Value Engineering Study

Dining Facility Prototypes

Prepared for
Norfolk District
US Army
Corps of Engineers

Subject: Value Engineering Report, Dining Facility Prototypes

A-17 Confirm that enough wooden doors are being used to count LEED point per spreadsheet

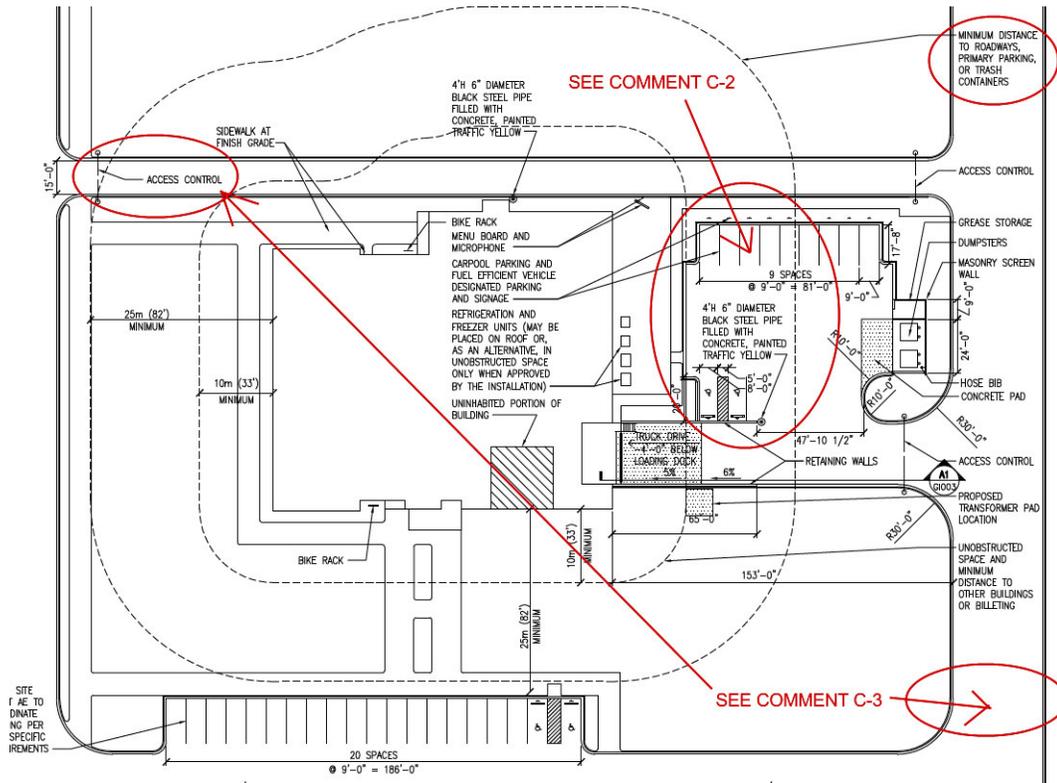
The U.S. Green Building Council (USGBC) has proposed a major change for certified wood in its LEED Rating System. Previously, LEED awarded credit to projects that used wood certified to the standards of the Forest Stewardship Council (FSC) for at least half of their wood-based materials. Now, USGBC has broadened the credit, recognizing any forest-certification program that meets its criteria. However, it is not clear whether there is a minimum amount of new wood being used on the project for this standard to be utilized as a metric.
